Our Ref: 23485_GRSF_Response to RFI Letter_V02_Final

5 April 2024

RE: Goulburn River Solar Farm - Response to DPHI RFI dated 31 January 2024

Figure 2.3 - Goulburn River AC Coupled BESS

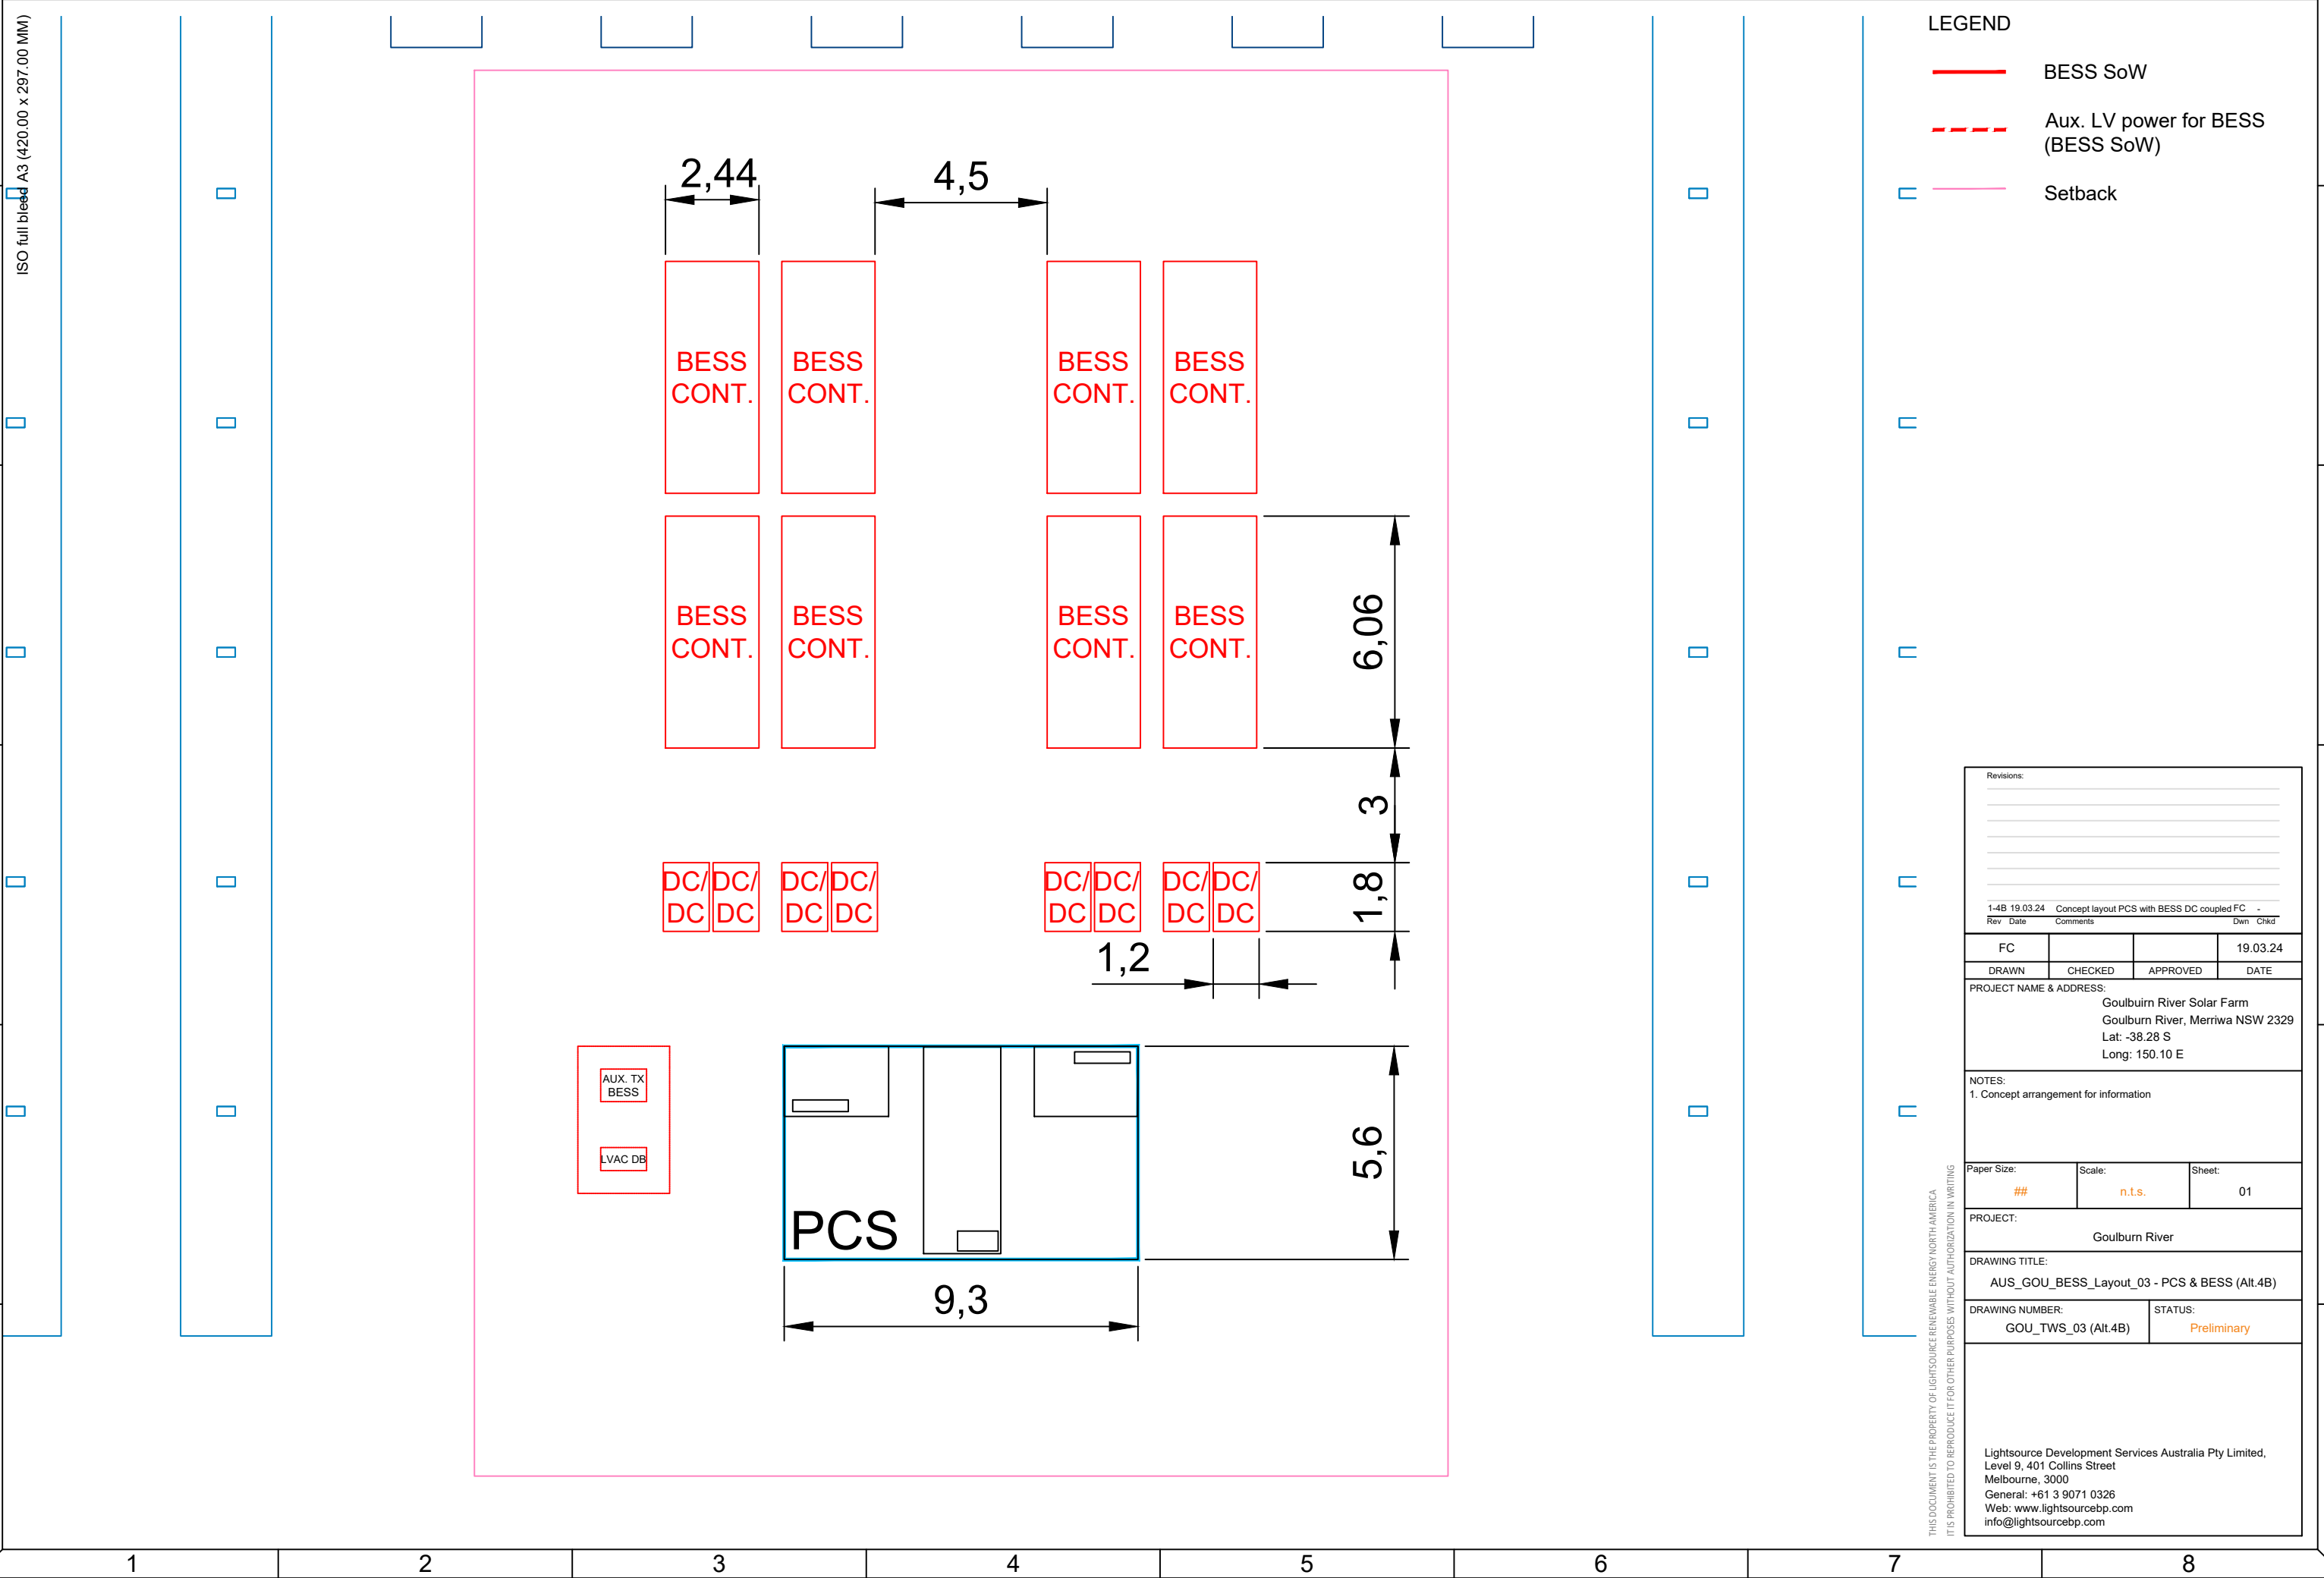
- 2. Considering the Li-ion battery will be located outdoor and Section 2.3.2 of FM Global Datasheet 5-33 is the correct reference for outdoor battery, provide further justification for the spacing of batteries to minimise the risk of propagation between batteries.*

- 3. Update the area requirements of the BESS based on the findings of Item 1 and Item 2 if required."*

The proposed centralised AC-coupled BESS includes:

- 258 battery storage cabinets approximately 6 m long, 2.4 m wide and 2.9 m high per station.
- A manufacture's specified energy storage capacity of 3.686 MWh per battery cabinet.

- A total nominated aggregate operational energy storage capacity for approximately 258 battery storage cabinets of 900 MWh.
- Cabinets installed with a space between facing battery storage units of up to 4.5 m. It is noted that in accordance with FM Global's Property Loss Prevention *Data Sheet 5-33 Lithium-Ion Battery Energy Storage Systems* (2023) the recommended minimum separation distance between the sides of lithium iron phosphate batteries containing access panels, doors or deflagration vents would be separated by at least 1.5 m (5 ft).

- A hardstand area for the centralised AC-coupled BESS of approximately 339 m by 185 m to allow for a separation distance between combustible vegetation and battery storage units of at least 3 m (10 ft) in accordance with *NFPA 855 Clause 443.6*¹.

- Access roads running between the banks of batteries are provided within the centralised AC-coupled BESS area.
- An AC-coupled BESS compound with a footprint of approximately 6.2 ha. Based on a maximum 'faceplate' storage capacity of 950 MWh, the approximate stored energy density of the centralised AC-coupled BESS would be 15 kWh/m².

It is considered that there will be sufficient area within the centralised AC-coupled BESS and each of the DC-coupled battery station to enable adequate separation distances between adjacent battery cabinets and other sensitive equipment to achieve non-propagation of thermal incidents.

Table 4-4: Turn warrants assessment (cumulative construction)

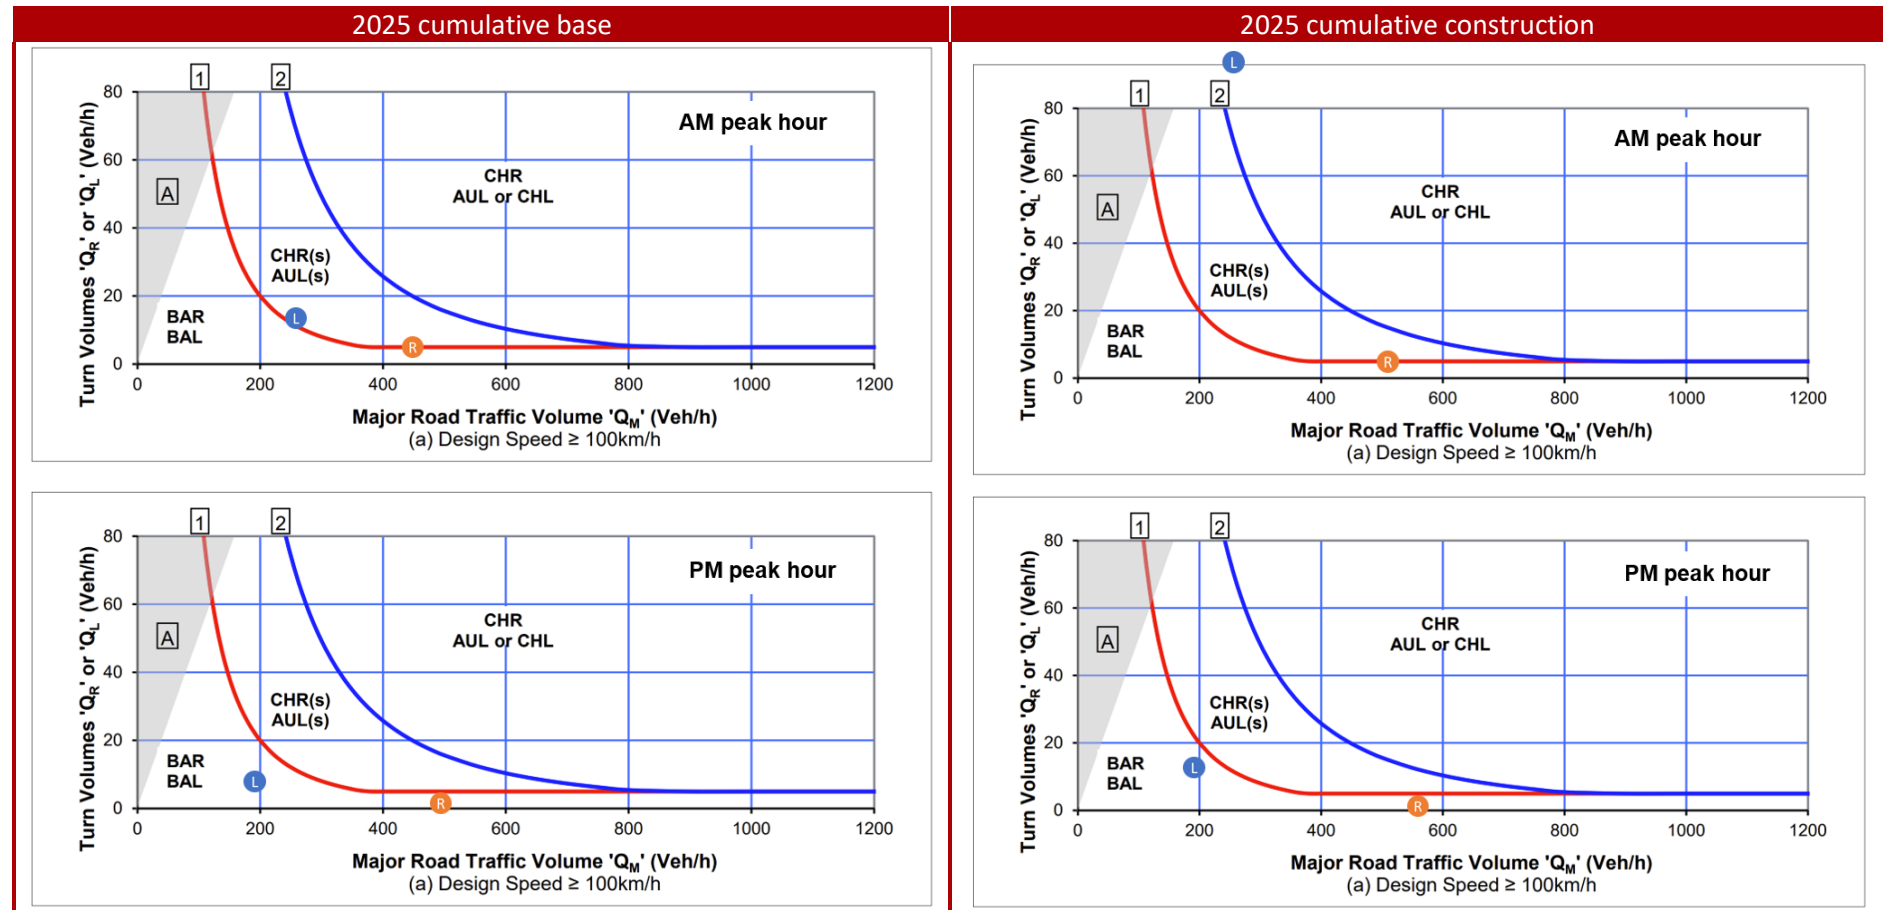
- *The existing Basic Right (BAR) turn treatment on Golden Highway is upgraded to a Channelised Right (Short) {CHR(s)} turn treatment. This is necessary given turn warrant treatments provided in Austroads Guide to Traffic Management Part 6 and the additional traffic that will pass through the intersection (eastbound) by virtue of the proposed TMP left out only turn movement onto Golden Highway and U-turn facility on Barnett Street.*
- *Measures to be employed to enforce and monitor compliance of the TMP, in particular the turn movement restrictions for vehicles entering the Golden Highway.*
- *Confirmation from Upper Hunter Shire Council of their approval of the use of Barnett Street for U-turn movements.*
- *Confirmation that the U-turn movement is performed within the Barnett Street road reserve, or alternatively, land owner’s consent where the movement is outside the road reserve.”*

Table 4.4 of **Appendix A** presents the results of the turn warrants assessment for cumulative construction vehicles, which show the Golden Highway left turn being marginally above the threshold for a AUL turn treatment, and the Golden Highway right turn being on the threshold of a BAR or Channelised Right (short) (CHRs) lane turn treatment being warranted during AM peak, being 7:15 am to 8:15 am.

As shown in Table 4-3, with Project only construction vehicles, at minimum the intersection would need a BAR and BAL to accommodate the proposed traffic volumes.

Table 5-4: Revised turn warrants assessment (cumulative construction)

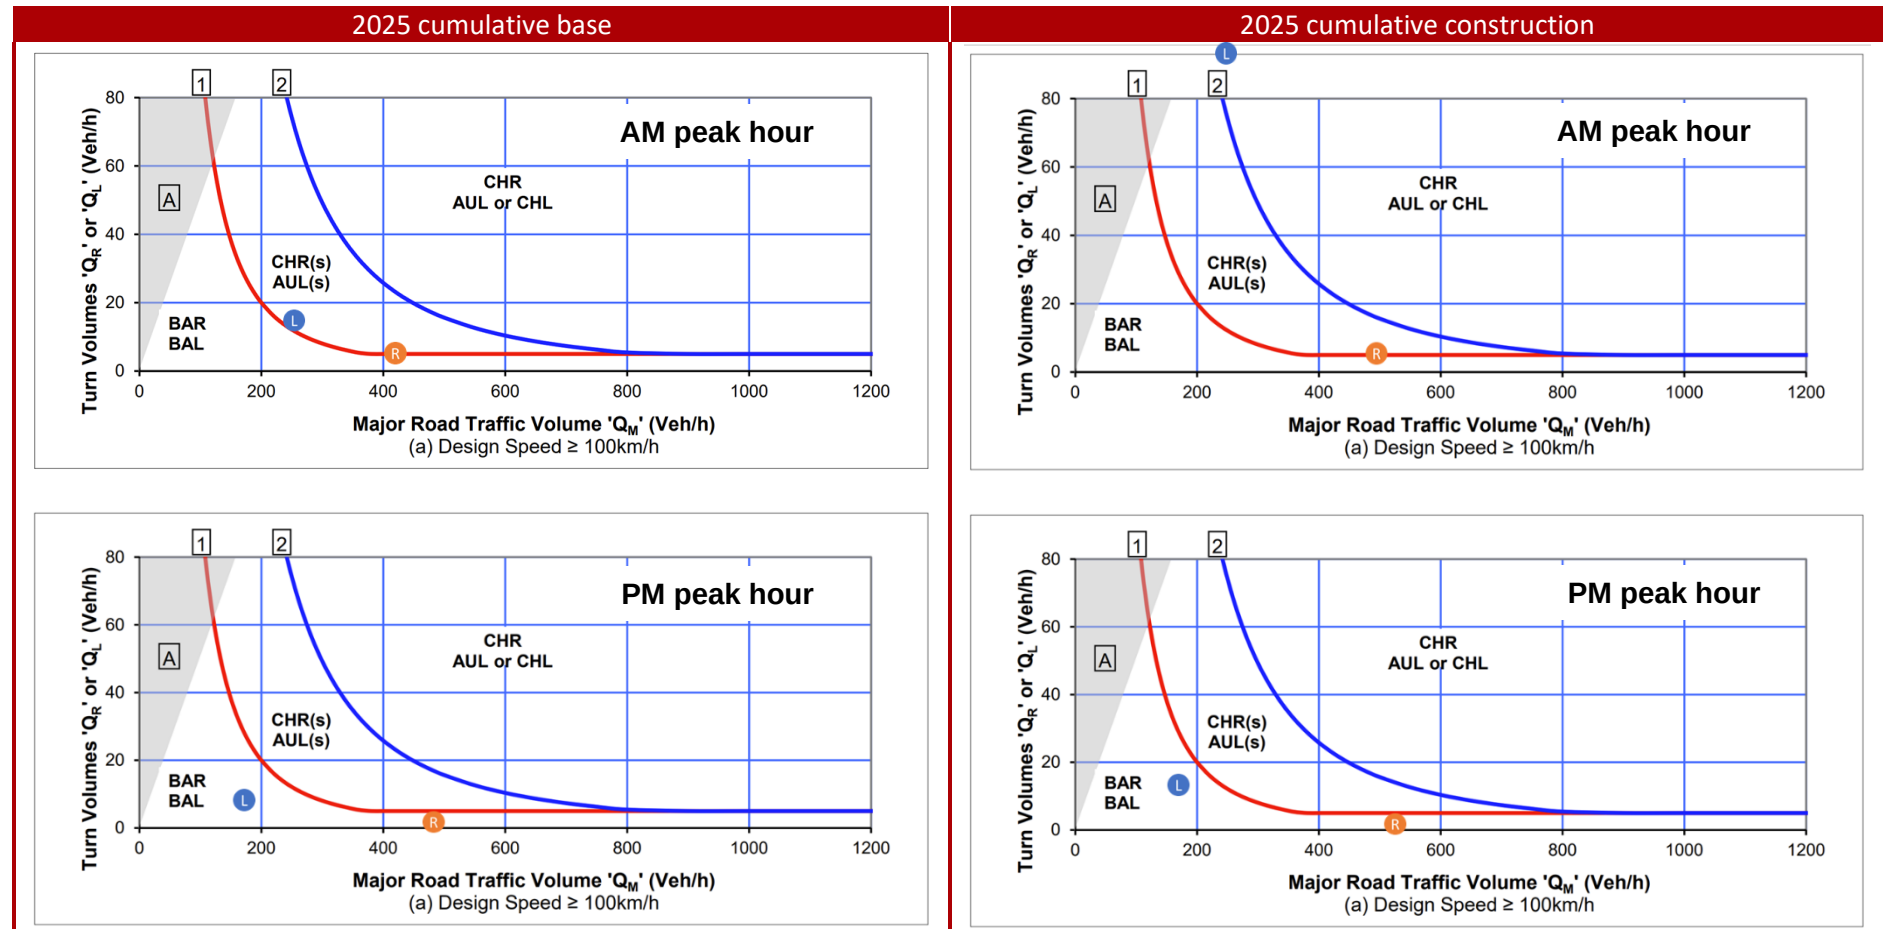
- Lightsource bp to undertake a revised turn warrants assessment using a 1.6% growth factor as per TfNSW guidelines, rather than the conservative 2% previously applied. Should this result in the same outcome, consider committing to traffic movements outside of peak times.
- Lightsource bp to undertake a Swept Path Assessment for the existing BAR into Ringwood Road.
- TfNSW raised no further comment in relation to the three remaining components of their response.

In discussions with TfNSW on 21 February 2024, it was determined that the 2% growth rate applied in the Amendment Report 1 was overly conservative and that TfNSW recommended the assessment was revised using a background growth rate of 1.6% (reduction from 2% per annum). Applying the lower background growth rate had minimal impact on the outcome of the turn warrants assessment, with the results indicating the same outcome as previously assessed: i.e. right turns during the AM peak period continued to remain on the threshold for a CHR(s) turn warrant treatment when considering cumulative construction traffic.

As shown in Table 5-3 and Table 5-4, the revised assessment for the right turn with a reduced background traffic growth rate shows that warrant for a BAR vs CHR is still on the threshold as there is a minimal change to the revised volumes.
